## **Fleet Services**

Accessibility Review

City of Duluth, MN

2013

**Photo 1:** Enlarge the concrete pad to provide maneuvering clearance at the main entry.

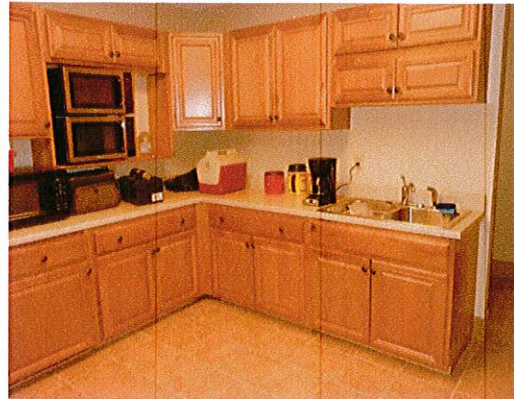
Location JQP # / Item #	Solution / Comments	Qty	Unit Cost	Total Cost	Priority	Estimated Compl. Date	Person Responsible	Actual Compl. Date	Actual Cost
<b>Building Wide</b>									
20D 15892	Provide door hardware that does not require grasping, pinching or twisting to operate, such as lever. ICC / ANSI 404.2.6	5	\$250	\$1,250	3				
<b>Conference Room</b>									
25J1 15894	Provide accessible faucet hardware. ANSI 804.4, 606.4 <i>Photo 2.</i>	1	\$450	\$450	3				
<b>Employee Entry- West</b>									
08D 15918	Bevel abrupt rises in the sidewalk. ANSI 303.3 <i>Currently a 3" rise.</i>	1	\$200	\$200	3				
<b>Main Entry</b>									
08D 15889	Bevel abrupt rises in the sidewalk. ANSI 303.3 <i>Photo 1.</i>	1	\$500	\$500	3				
12B1 15890	Extend sidewalk to provide appropriate maneuvering clearance on the latch side of the door. ICC / ANSI 404.2.3.1 <i>Photo 1.</i>	1	\$500	\$500	3				
				<i>Location Subtotal:</i>					\$1,000

Building Wide

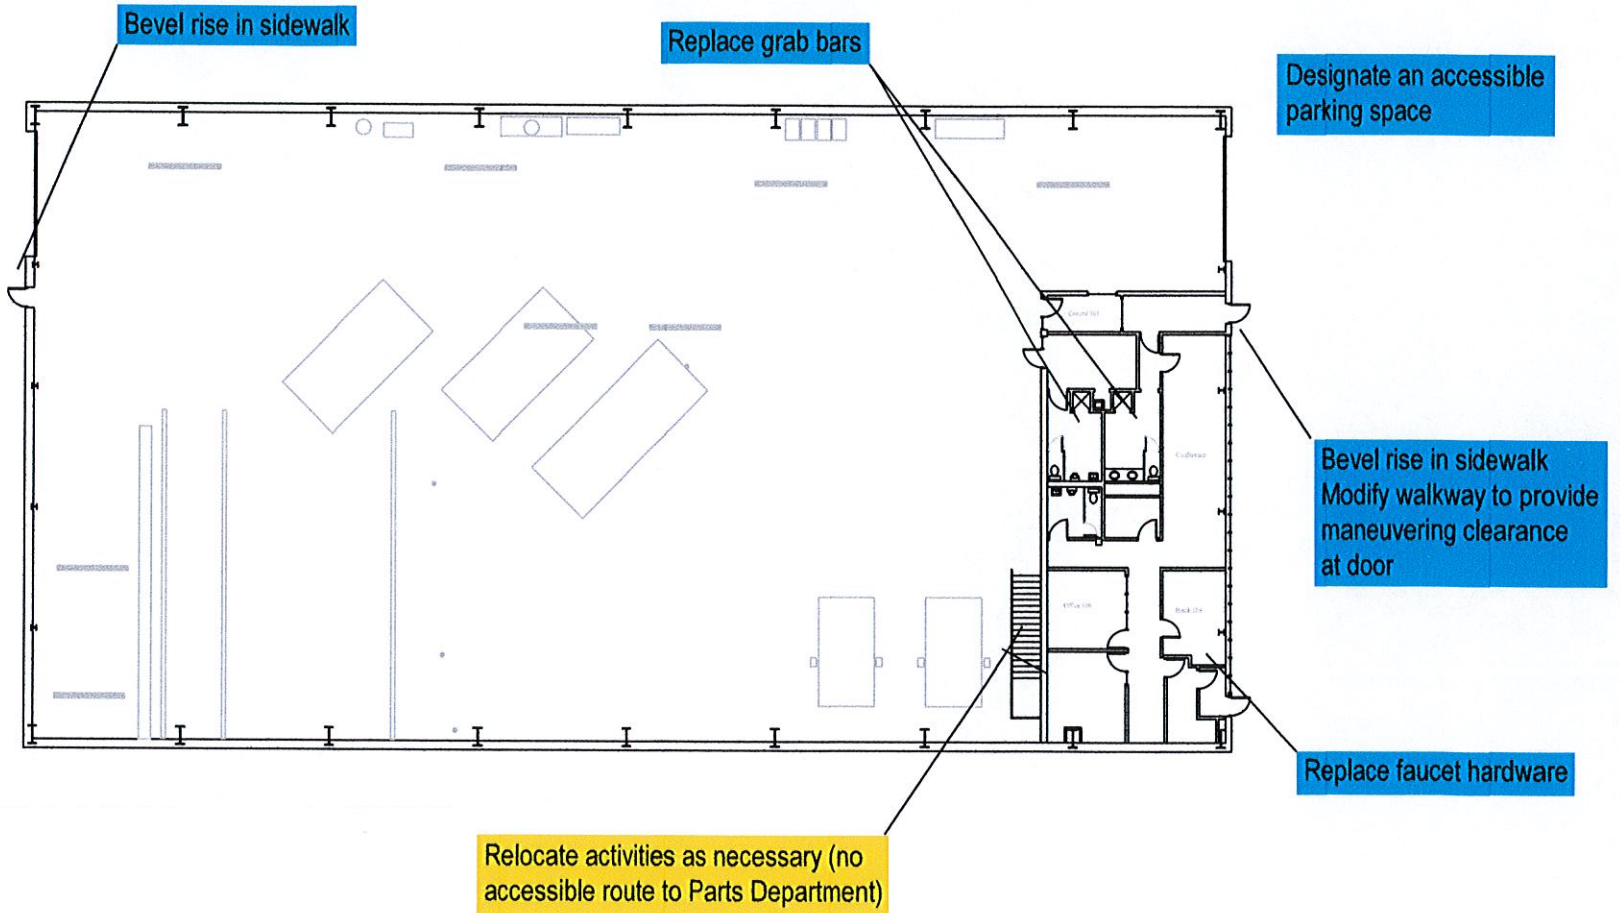
Replace knob style door hardware
